**ZONING AMENDMENT
PLANNED UNIT DEVELOPMENT &
SUBDIVISION STAFF REPORT**

Western Properties Subdivision

709 Western Drive
(Northwest corner of Western Drive and Northwest Drive)

SITE PLAN

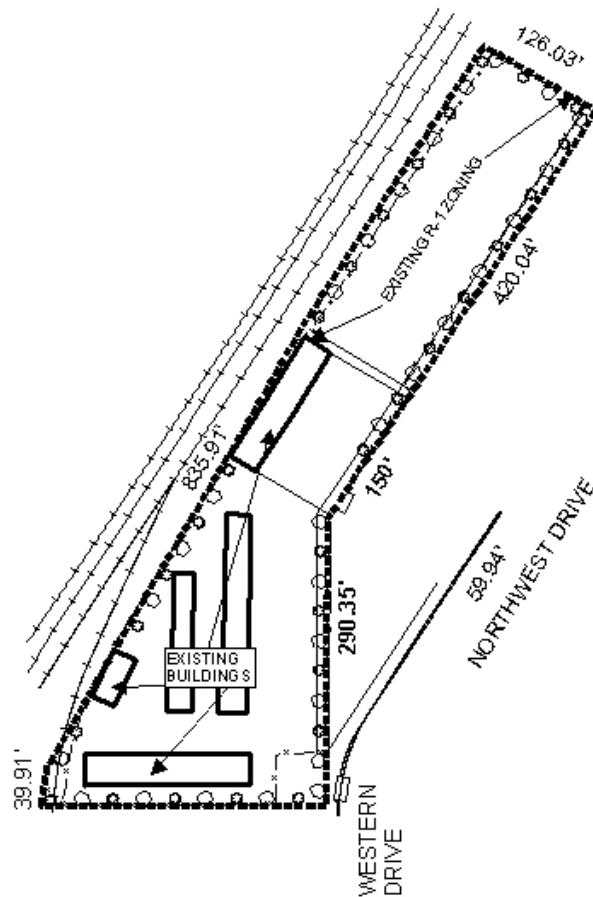
As illustrated on the site plan, it appears that the only proposed change to the property is a new access point to Northwest Drive. However, this driveway would be zoned industrially and as such 18-wheelers would be driving between two existing residential structures. While the current zoning would prohibit a second point of access, redesign/renovation of the existing site, or limiting deliveries to smaller vehicles would allow the passage of emergency vehicles.

RECOMMENDATION
recommended for denial.**Rezoning** Based upon the preceding, this application is**Planned Unit Development** Based upon the preceding, this application is recommended for denial.**Subdivision** Based upon the preceding, this application is recommended for denial for the following reason: 1) approval of the application would create a split-zoned lot.*Revised August 19th meeting:**The applicant has submitted a revised plan excluding the residential lot along Western Drive. While the rezoning would still expand the I-1 district northwardly behind residential properties, all of the access would remain to the South in the commercial/industrial area. Moreover, due to the configuration of the property as well as issues of access, it is improbable that this sliver of property would ever be developed residentially.**The site plan illustrates a 10-foot buffer strip adjacent to residential development, which is the minimum buffer required by the Zoning Ordinance; this situation (industrial property adjoining residential) would necessitate a minimum buffer of 15-feet, as well as the provision an eight-foot wooden privacy fence.**In regard to the proposed PUD, the existing site would essentially remain as is, however, all the parking, access and maneuvering is illustrated as shell. Typically rezoning and PUD approvals require full compliance with all municipal codes and ordinances, including paved parking and landscaping and tree plantings. It should be noted that as a PUD, any changes to the proposed site plan other than specific conditions placed upon this approval would require a new PUD application.****Rezoning:*** *Based upon the revised site plan, this application is recommended for approval subject to the following conditions: 1) the provision of a 15-foot vegetative buffer and an eight-foot wooden privacy fence where the site adjoins residential development; 2) the paving of all access, maneuvering and driveways; 3) full compliance with the landscaping and tree planting requirements of the Ordinance; and 4) full compliance with all municipal codes and ordinances.****Planned Unit Development:*** *Based upon the revised site plan, this application is recommended for approval subject to the following conditions: 1) the provision of a 15-foot vegetative buffer and an eight-foot wooden privacy fence where the site adjoins residential development; 2) the paving of all access, maneuvering and driveways; 3) full compliance with the landscaping and tree planting requirements of the Ordinance; and 4) full compliance with all municipal codes and ordinances.****Subdivision:*** *The plat meets the minimum requirements of the Subdivision Regulations and is recommended for approval.*
